Docket Item #8  
BAR CASE # 2017-00230

**ISSUE:** Certificate of Appropriateness for alterations

**LOCATION:** 1310 Michigan Ave

The applicant is requesting approval of a Certificate of Appropriateness for exterior alterations on the west facade. The property at 1310 Michigan Avenue is a thru lot that is considered in the zoning ordinance to have two front yards with the west elevation, which is architecturally the rear facade, fronting on Seaport Lane. The existing window and single door will be removed and a new 53" x 35.5" opening will be created for a new pair of eight-light Jeld-Wen brand Summit model casement windows. The application does not contain complete window specifications but represents that the proposed window will be in accordance with the BAR's window policy. The area around the new window will be in filled with brick. The proposed changes are similar to alterations made to the rear of 705 and 707 Bashford Lane nearby.

ORIGINAL ELEVATION – REAR

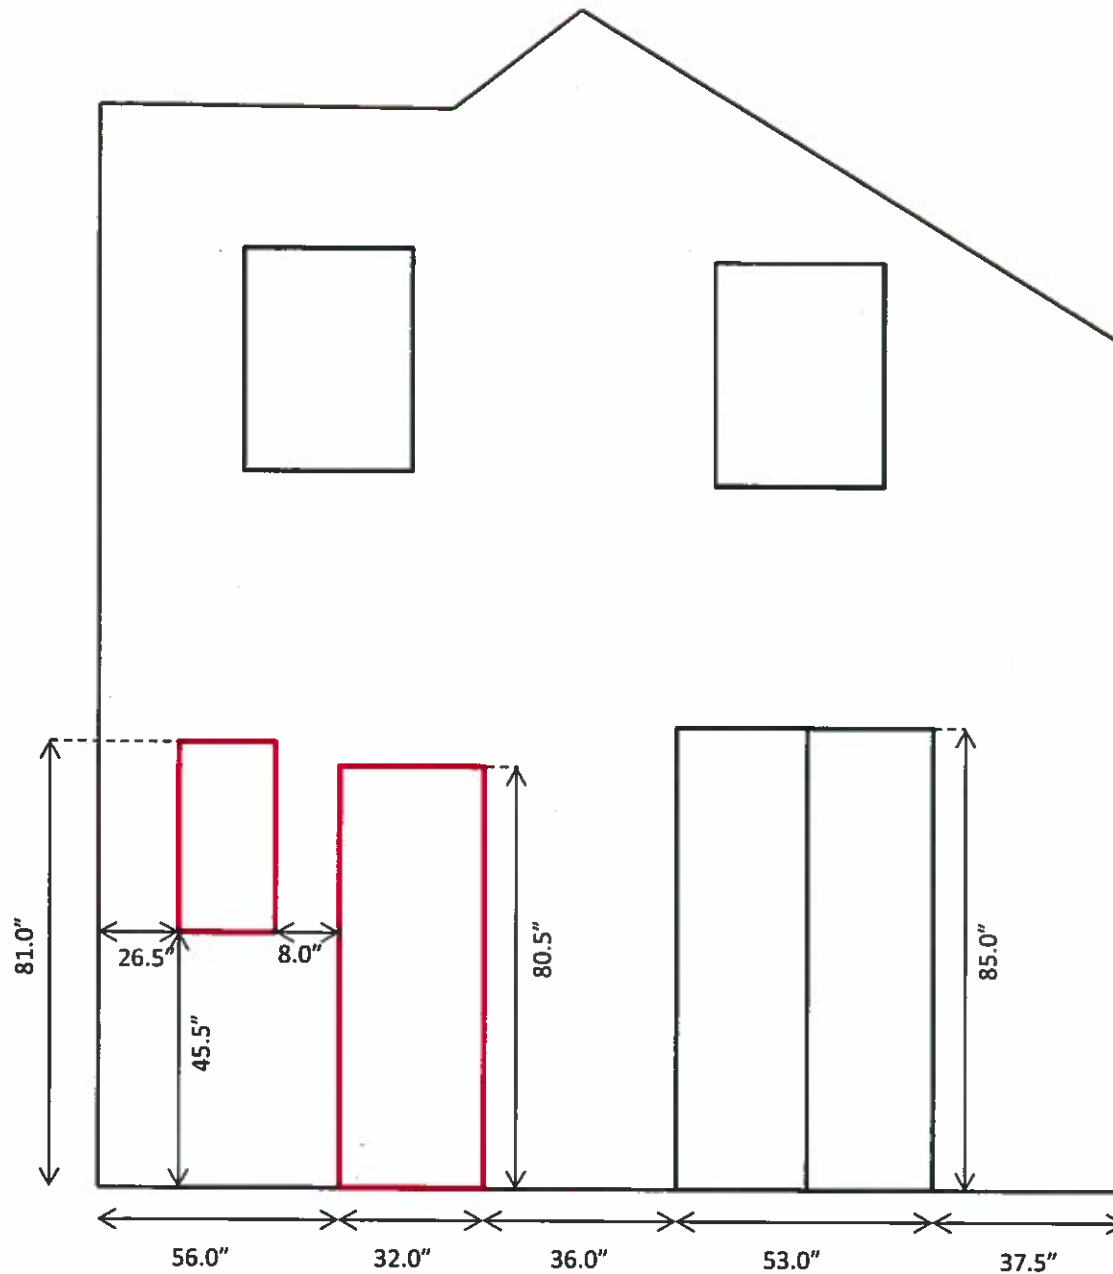
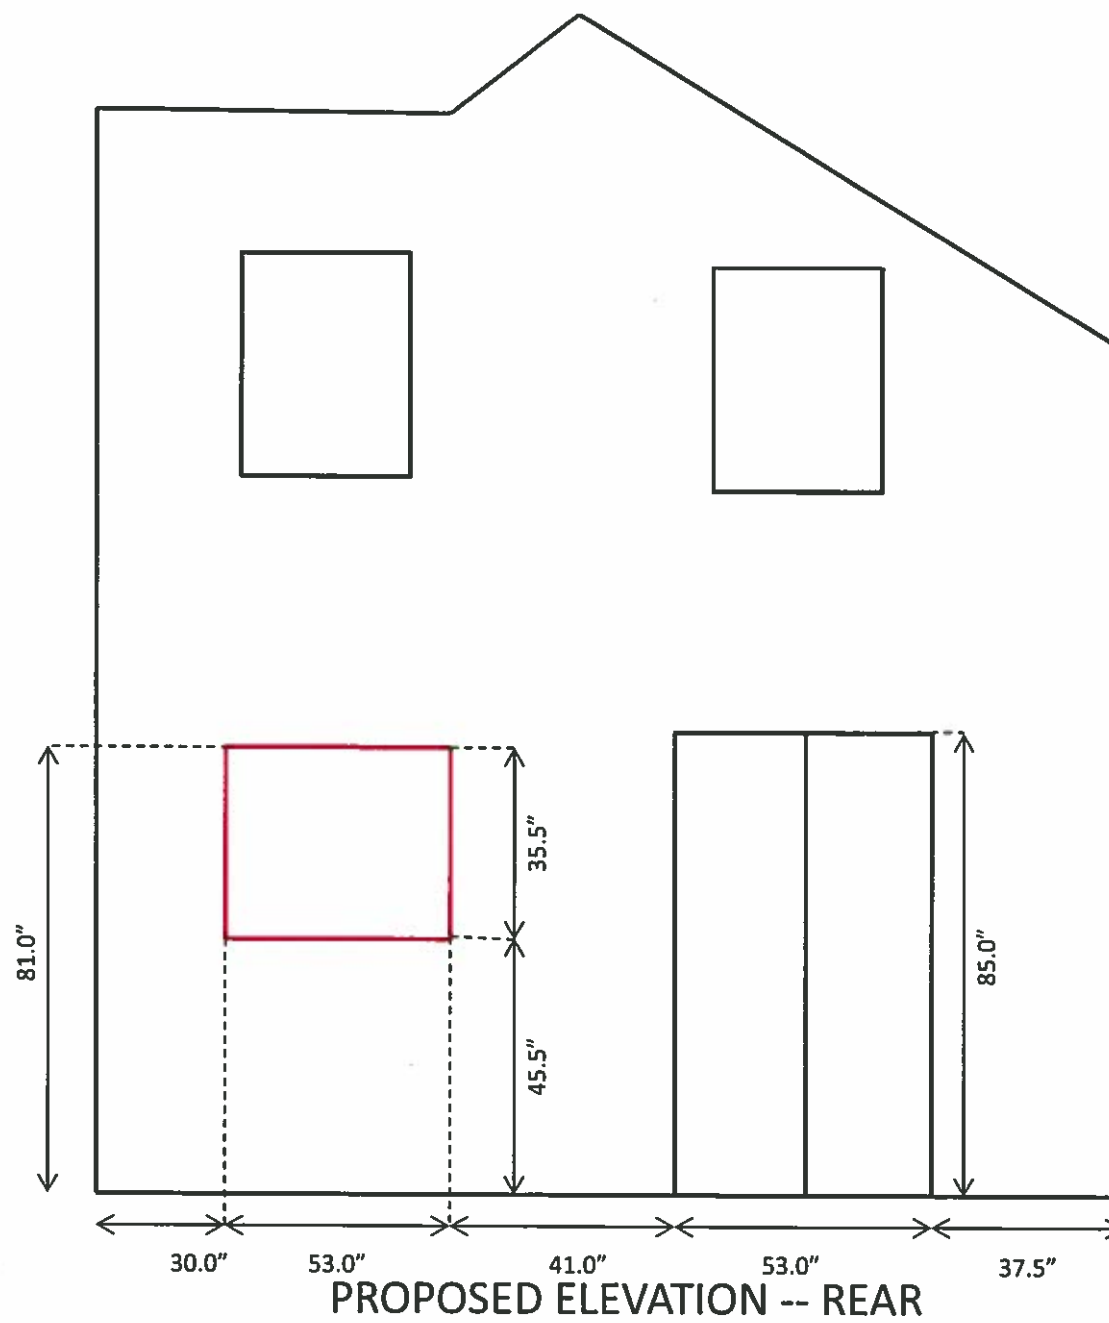
1. That the brick that is being removed from under the existing rear first floor window is salvaged and used to fill in the area below the new window opening and that the color, composition and profile of the repair mortar match the existing.
2. That the replacement window be fiberglass or aluminum clad wood with an appropriate muntin pattern to be approved by staff and that otherwise conforms with the *Alexandria Replacement Window Performance Specifications*.

Staff recommends that the applicant carefully salvage the brick that is being removed, so that it can be used to fill in the area below of new window opening. As always, the new mortar composition, profile and color should match the existing.

PROPOSED ELEVATION – REAR  
WITH NEW WINDOW (IN RED) RELATIVE TO ORIGINAL WINDOW AND DOOR

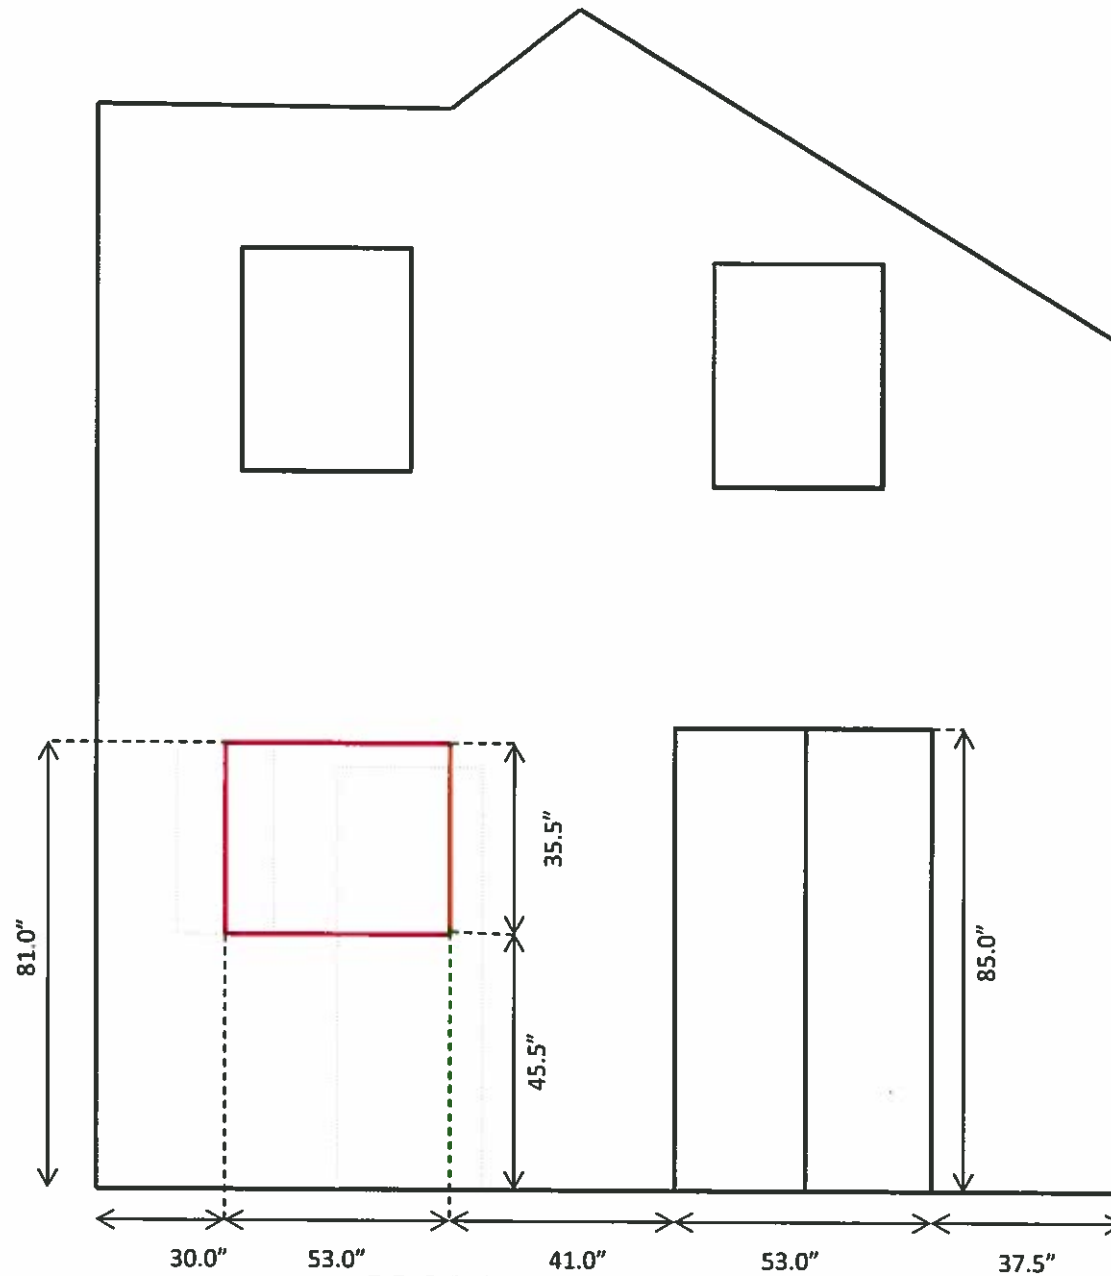
Staff notes that the existing windows on the house appear to be vinyl with muntins (grids) sandwiched between the panes of glass. These were not approved by the BAR and do not comply with the BAR's adopted window policy. The present application does not contain complete window specifications but represents that the proposed window will be in accordance with the BAR's window policy. The Summit Vinyl Collection model by Jeld-Wen does not comply with that policy. While the issue of the existing unapproved windows will be resolved separately, staff cannot support the installation of an additional vinyl or, sandwich muntin window. However, staff can support a simulated divided light (SDL) fiberglass window in this location, as long as it otherwise complies with the BAR's Window Policy.

Therefore, staff recommends that the BAR approve this application with a fiberglass window with an appropriate muntin pattern to be approved by staff and that otherwise conforms with the *Alexandria Replacement Window Performance Specifications*.
